DRAWN & DRAFTED BY	LIU YOU SEN	TOLERANCES		ANGLE:	TITLE:		
		$0<L\leq 4 \pm 0.1$	pin pitch ± 0.2	$\pm 1^\circ$	BOBBIN BP-E28P		
CHECKED & APPROVED BY		$4<L\leq 16 \pm 0.2$		UNIT:	BOBBIN MATERIAL:	UL REC.	
		$16<L\leq 63 \pm 0.3$	MM	PHENOLIC (PM-9820)	UL 94V-0		
 PIN SHINE INDUSTRIAL CO.,LTD. TEL:+86-596-7880558 FAX:+86-596-7880556				ORIGIN:	PIN MATERIAL:	PIN TENSION LOAD:	
				ZZ	CP WIRE	2.0KG MIN	
					DATE:	DRAWING NO.	REV.
					AUG.28.2003	P-2818	5

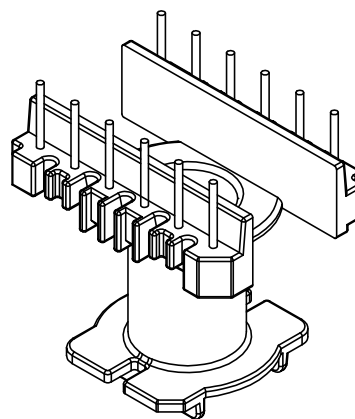
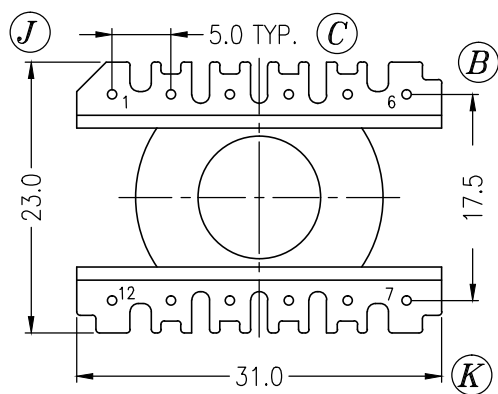
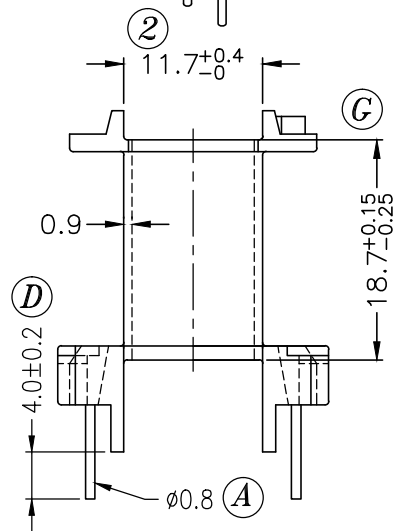
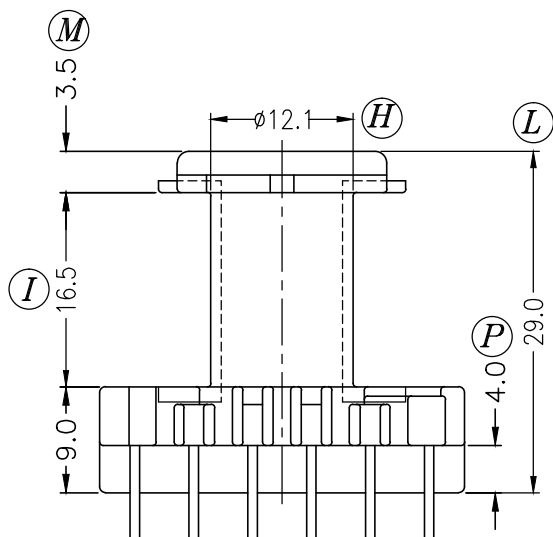
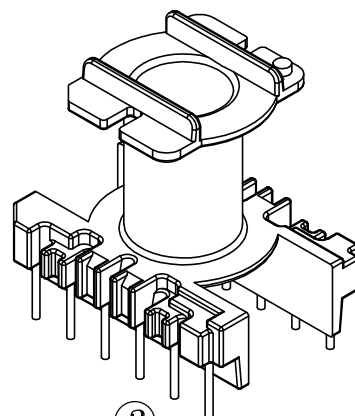
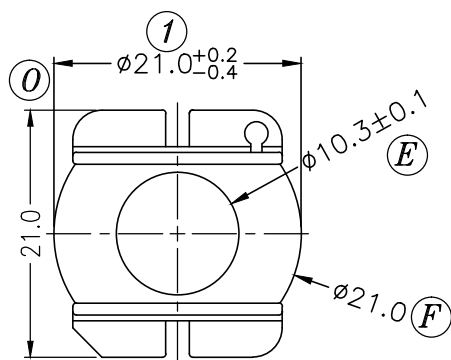
REV.	REVISIONS	REC.	DATE	REV.	REVISIONS	REC.	DATE
1	①② ③ 修改公差			5	(E):10.3+0.1/-0.1->10.3±0.1		
4	顶部的凸点与挡墙连接起来，铁芯长度由18.7±0.1改为18.7+0.15/-0.25，壁厚由0.9±0.05改为0.9
